28 October 2019

Our ref: 19ARM 13082

RE: Stringybark Solar Farm DA - 112-2019 - Request for additional information

Figure 1: Cumulative silver (left) and zinc leaching from the samples in the rain run-off experiment conducted in duplicate. The amounts are expressed in mg per m² of Organic photovoltaics (OPV) (right axis) and the corresponding share of leached material (left axis).

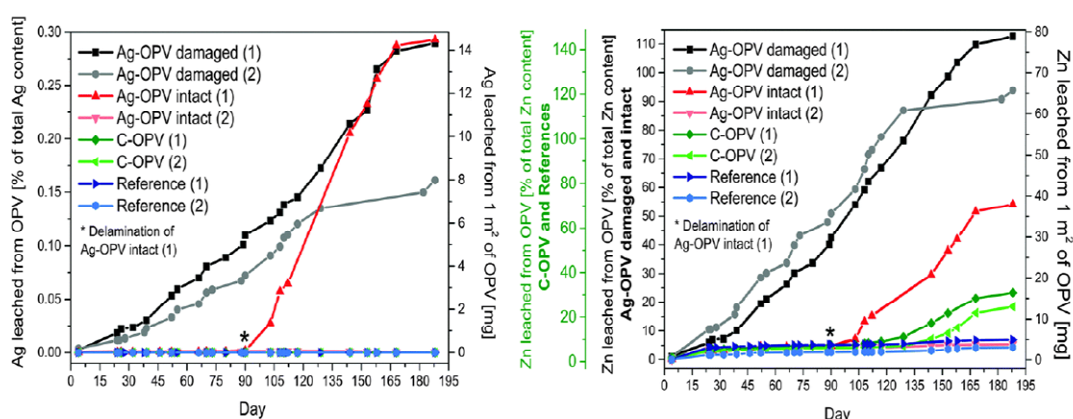
Council has reviewed the environmental pollution components of the Stringybark Solar Farm Statement of Environmental Effects and attempted to cross-reference findings and some concerns raised in public submissions with an array of scholarly scientific literature. While extant literature on solar modules' contamination of the environment is conflicting on a number of analytic metrics, and on spatiotemporal differences, there are some studies that appear to point toward rainwater-leaching and life-cycle toxicity of cadmium, copper, lead, silver, nickel, tin and zinc from solar modules. For example, silver and zinc were leached from operational intact and damaged solar modules observed for 6 months in Denmark (see Figure 1). Another study showed that copper (I) thiocyanate and lead (II) iodide can leach out quickly during PV use phase.

As such, could you please provide some manufacturing details of the solar panels. It is noted in a number of studies that encapsulation of some PV structural components reduces potential incidence of rainwater-induced leaching. Consequently, newer PVs have solder and other components produced without lead and toxic metals.

Lastly, it should be noted that Organic Solar Panels (referred to in Figure 1 in the correspondence provided by Council) are not available for commercial use for utility scale solar farms due to a current lack of commercially viable technology and would not be considered for the Proposal.

Regarding the charts provided, they are for organic photo voltaic systems. The typical installation of solar farms in Australia is of the form of Crystalline Silicon Photo Voltaics. There is no zinc present inside these modules and minimal silver.

In a high quality module, the encapsulant prevents the deterioration and emission of these elements from the module. I have seen no evidence of any leakage of heavy metals or dangerous chemicals from C-Si modules.
